The Executive Chairperson  
Planning Authority  
St. Francis Ravelin,  
Floriana

Date: 26 May 2025  
ERA Ref: EA/00004/20

PA Ref.: PA/09876/19 & PA/01948/20  
Description: Proposal of demolition of existing hotel; & Proposed development of hotel (Class 3B)  
Proposal: with ancillary facilities including storage of LPG tanks and excavation works, following the demolition of the existing hotel (PA/9876/19). Proposal also includes soft/hard landscaping, pools, restoration/construction of rubble walls, and restoration of part of the coast. Total proposed number of guest rooms is 421 rooms.  
Location: Site at, Mellieħa Bay Hotel, Triq il-Marfa, Ġhadira, Mellieħa.

**Figure 1** – Complex site area - approved (yellow) and proposed (red) (Source: EIA Coordinator's Statement, 2025)

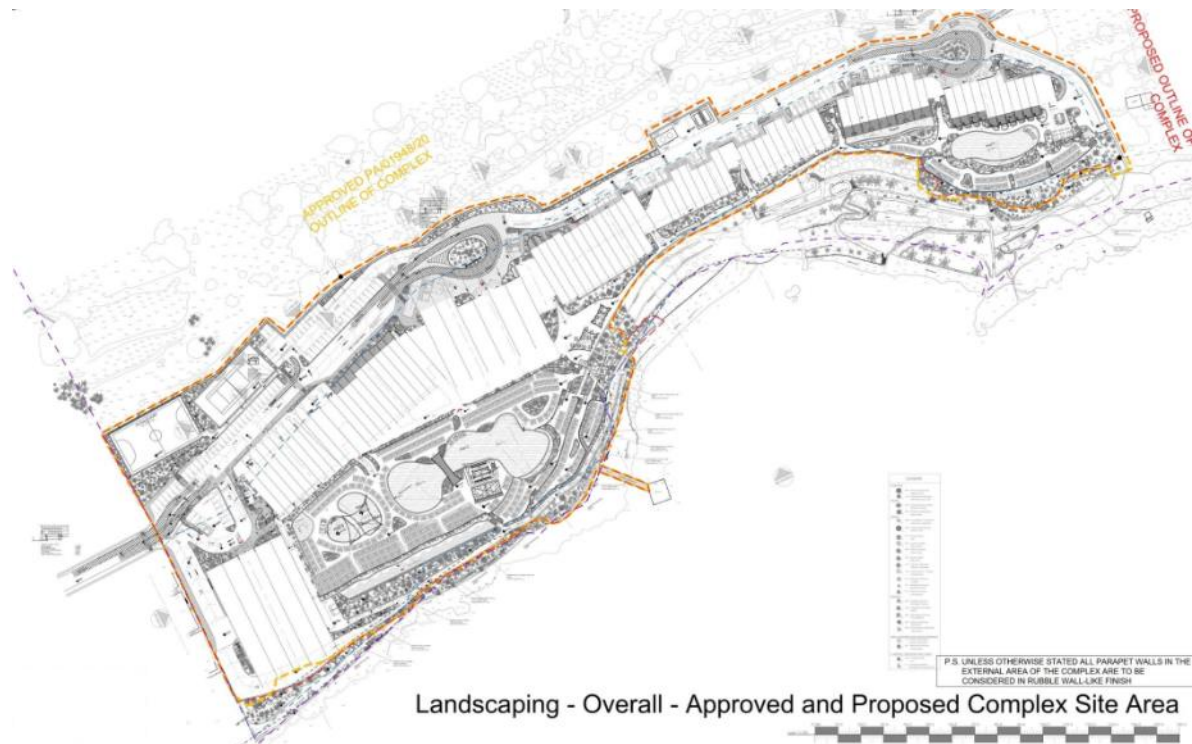
- Changes to the massing and architectural design of the buildings;
- Reduction in built-up area (-85 m<sup>2</sup>, resulting in 36,460 m<sup>2</sup>), building footprint (-3,106 m<sup>2</sup>, resulting in 12,100 m<sup>2</sup>), and gross floor area (-7,503 m<sup>2</sup>, resulting in 43,477 m<sup>2</sup>). Note: no changes proposed to the northern boundary, facing the rural area);
- Reduction in heights of all building blocks (ranging from 1.13 m to 5.63 m in height reduction), except for one building block for which an increase of 1.4 m is proposed. The maximum height is reduced by 0.7m to 38.05m.

**Figure 3** – Photomontages – previous hotel (upper), approved (middle) and proposed (upper)  
(Source: 2022 EIA Report and 2025 Coordinator’s Statement).

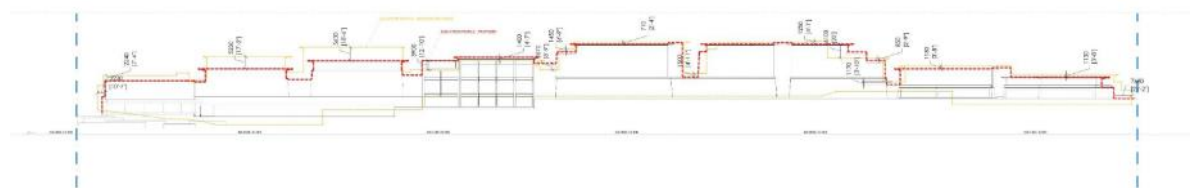
Apart from one viewpoint (Triq il-Marfa), the significance of the project's visual impact (as seen from the various long- medium- and short-distance viewpoints assessed) would remain similar as for the approved development. With respect to the view from the Northern approach road (Triq il-Marfa), the proposed lowering of the development reduces the developments' intrusion into the bay's landscape and therefore also its significance in terms of visual impact.
